PRODUCT BULLETIN

SP470200 / SP470201 – December 2009

Subject: Timken Provides OE Solution

SP580310

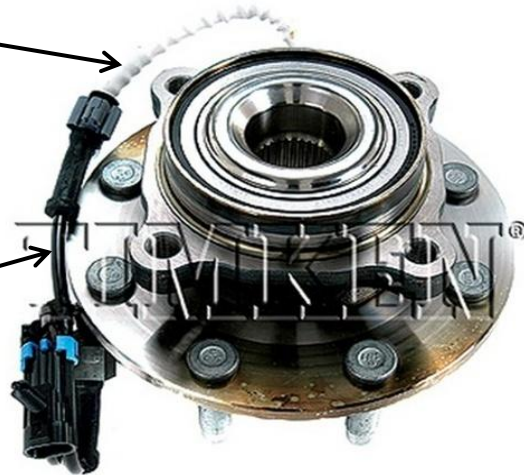
It has come to our attention that GM **"MAY"** have made a mid-model year change to bearing assemblies for SOME 2007 applications listed below.

Both hubs look exactly a like EXCEPT the earlier verison has larger size ABS Sensor Wire and White Boot coming off sensor connection.

**WHITE BOOT COVERING
COMING OFF THE SENSOR**

**LARGER DIAMETER ABS
SENSOR WIRE**
